**STAFF REPORT
FOR THE PLANNING COMMISSION**

FILE NUMBER: SUB-14-01/VAR-14-01/VAR-14-03/VAR-14-04/VAR-14-05/MISC-14-02

REQUEST: 4-lot subdivision with four Class II Variances and a permit to Enlarge/Alter a Non-Conforming Structure at 1770 Ostman Rd.

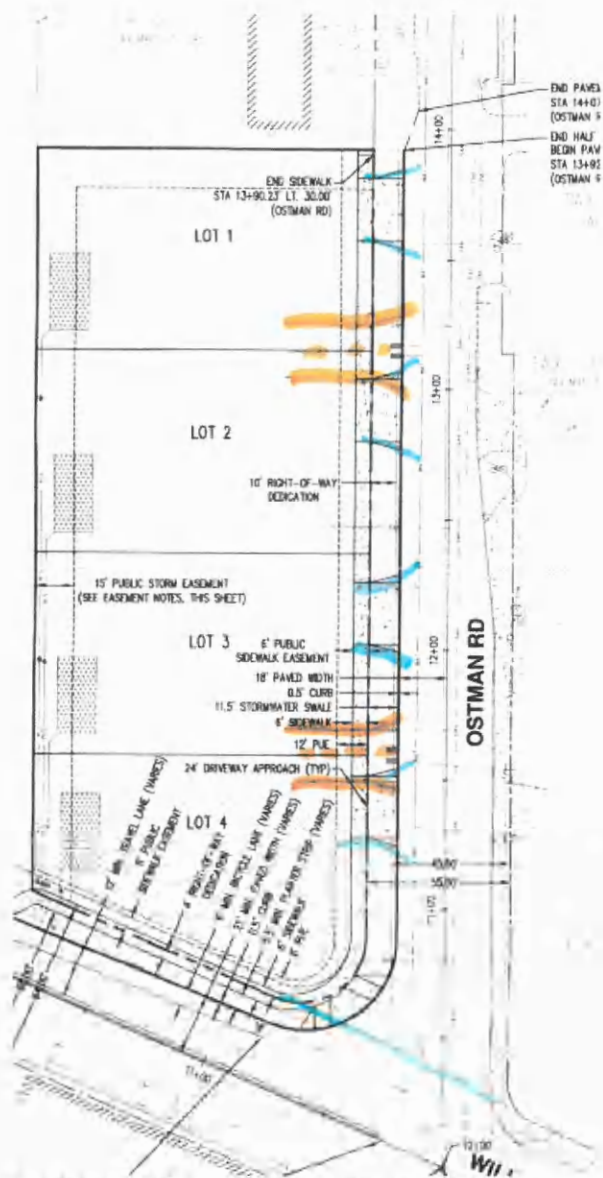
The 128-foot calculation is based on how each abutting driveway in the set would have to be a minimum of 10 feet wide, with three feet on each side of the combined driveway for curb cut wings, for a total of a 26-foot-wide curb cut. See the graphic below for a visual representation of this. Not only would two of the requested variances related to distances between

driveways be irrelevant under this scenario, but as shown on the graphic below, there could be 100 feet from the lot 3/4 driveway to the projected right of way line of Willamette Falls Drive. This would make a third of the four variances irrelevant as the project would then meet 48.060(C)(4) as well.

As for the remaining variance, having 128 feet between the two sets of combined driveways would meet 48.060(D)(2) requiring the 75-foot separation between curb cuts, but it would still have the driveways 22 feet closer than the 150-foot distance required by the TSP table via 48.025(B)(6). Still, having one variance for 22 extra feet of separation makes for an overall minimum variance effect compared to what is requested by the applicant. Under the applicant's request, there are three driveway separation variances each with over 100 feet of distance from the standard, plus the variance for driveway separation distance from the Willamette Falls Drive intersection.

PRELIMINARY SUBDIVISION PLAT WITH BUILDING SETBACKS

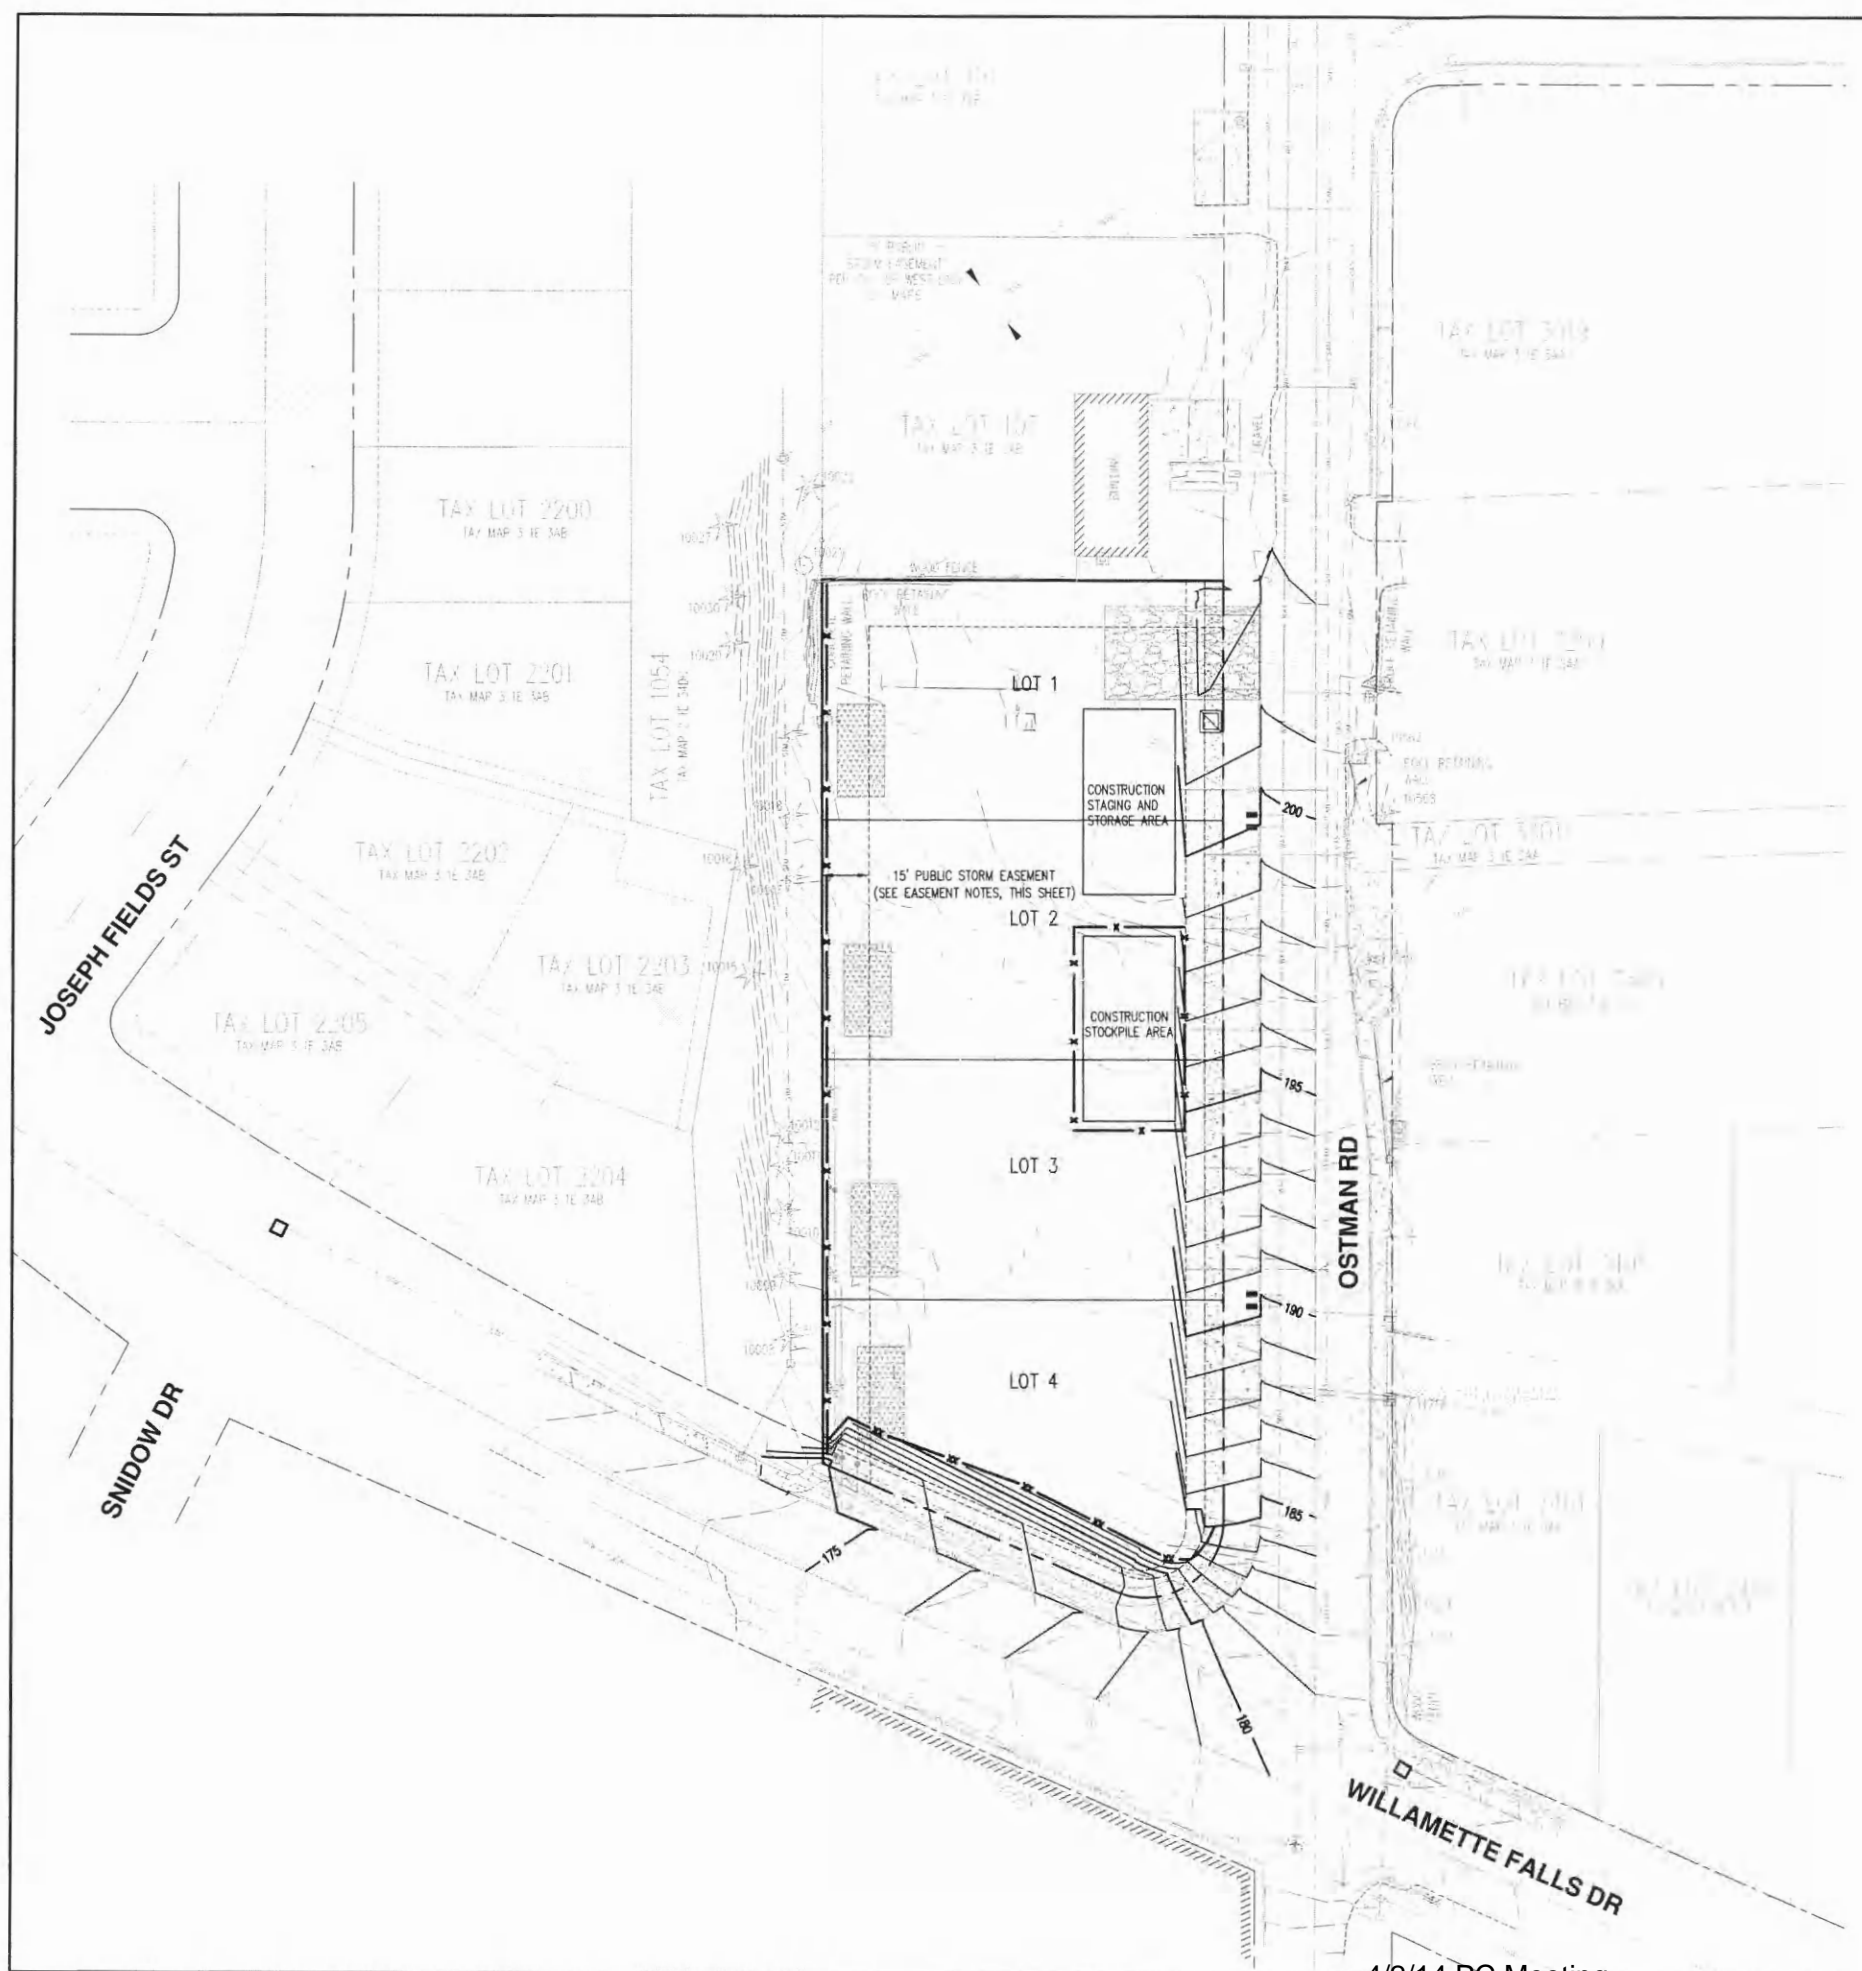
1. **Site Plan.** With the exception of modifications required by these conditions, the project shall conform to the Preliminary Subdivision Plat With Building Setbacks, Sheet 5, dated February 21, 2014, located on Page 50 of Exhibit PC-4.
2. **Sidewalk Along Bus Stop.** The applicant shall widen the sidewalk and the proposed public sidewalk easement to eight feet along the existing bus stop.
3. **Engineering Standards.** All public improvements and facilities associated with public improvements including grading, onsite stormwater design, street lighting, easements, and easement locations are subject to the City Engineer’s review, modification, and approval.
